T10/08-312 revision 1

To: T10 Committee (SCSI)

From: George Penokie (LSI)

Subject: SAS-2: Making 07-193 into an Annex

Figure 1 — Reference transmitter test load physical characterization

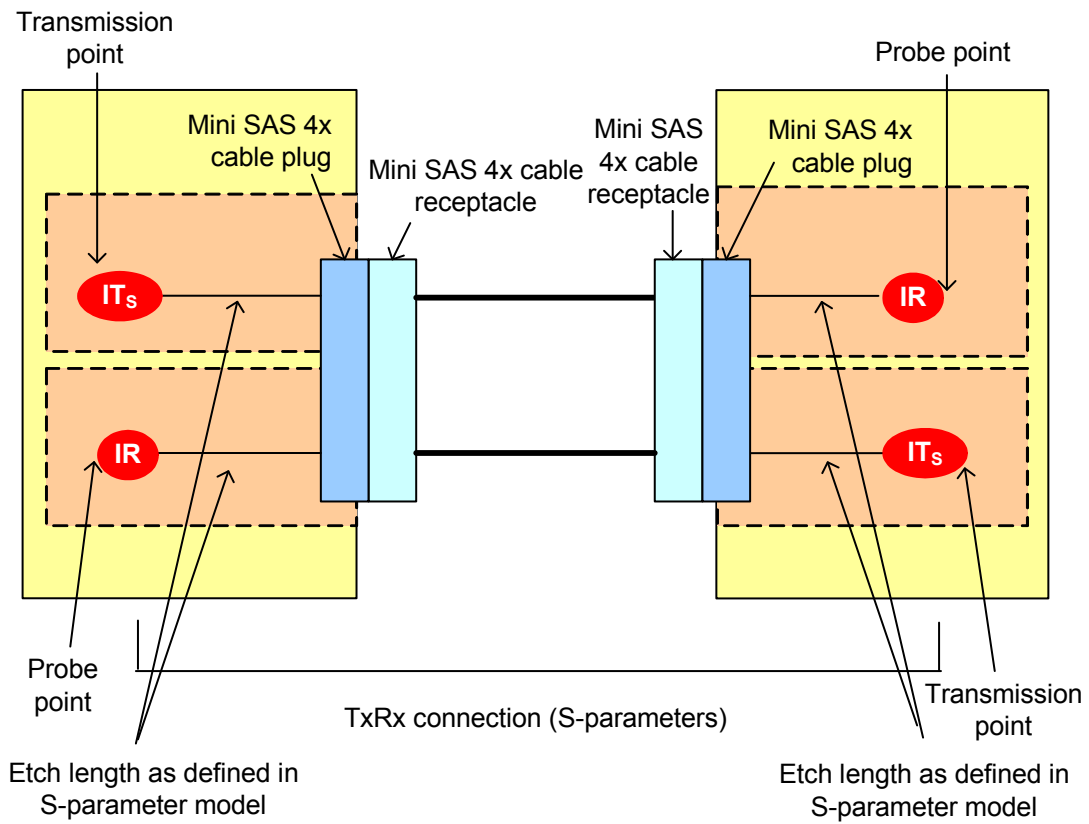
Figure 1 shows the physical model used to measure the reference transmitter test load. The etches between the transmission points and probe points may be included in an S-parameter measurement of a TxRx connection. Although these etches add extra loss to the TxRx connection, they are considered to be an

acceptable amount of loss for simulation purposes when restricted to a configuration similar to the reference transmitter test load.

Figure A.1 — S-parameter model of the reference transmitter test load

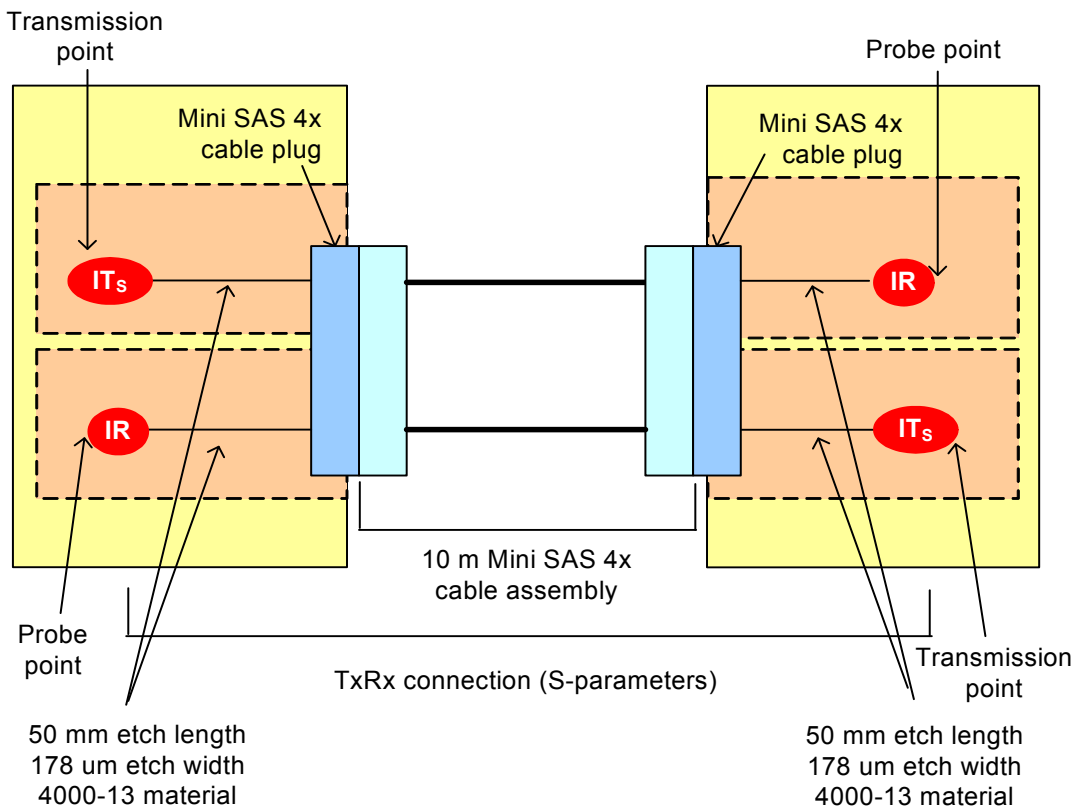
The S-parameter model of the reference transmitter test load consists of:

- a) an etch length of 50 mm with an etch width of 178 μm between the IT_s (see 5.3.6.5.4) and the Mini SAS 4x cable plug (see figure A.1) in 4000-13 material environment;
- b) 10 m Mini SAS 4x cable assembly; and
- c) an etch length of 50 mm with an etch width of 178 μm between the IR (see 5.3.7.4.3) and the Mini SAS 4x cable plug (see figure A.1) in 4000-13 material environment.

Figure A.2 — S-parameter model of the reference transmitter test load setup

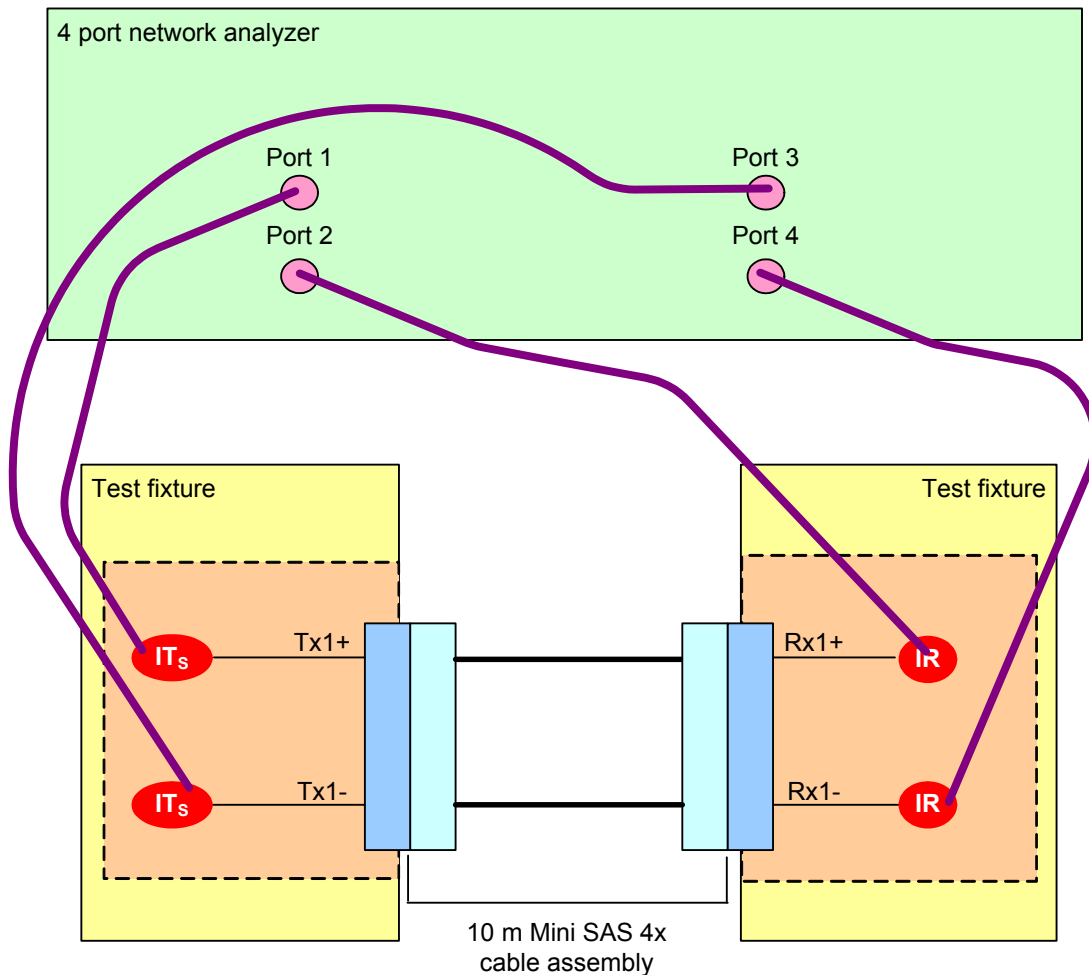
The equipment is interconnected as shown in figure A.2.

Figure A.3 — Reference transmitter test load waveform

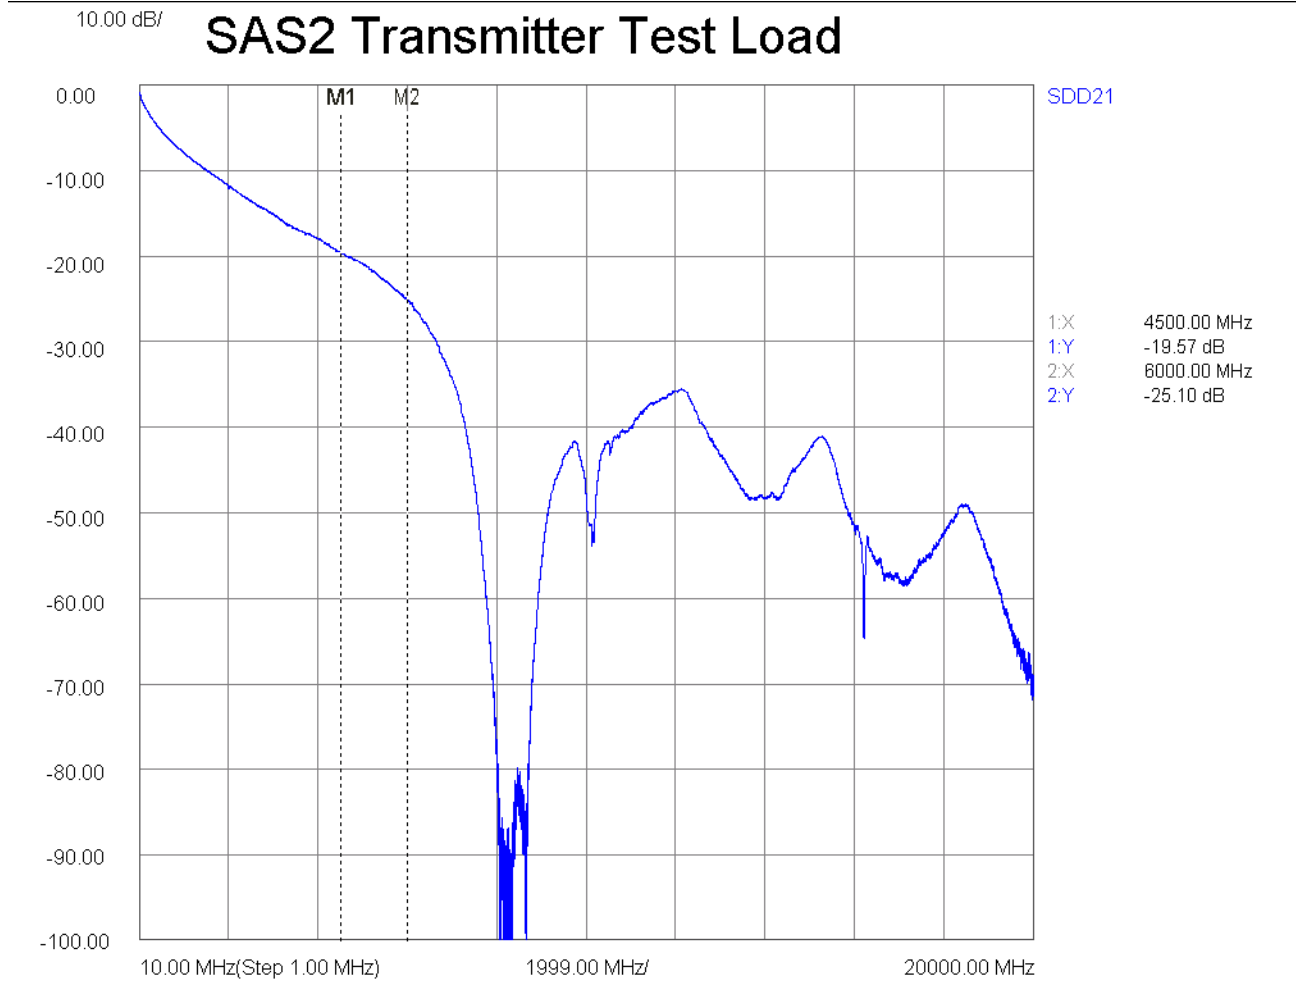
To generate the S-parameters for the reference transmitter test load sweep the 4 port network analyzer from 10 MHz to 20 GHz in 1 MHz steps. The resulting differential insertion loss waveform should be similar to that shown in figure A.3.
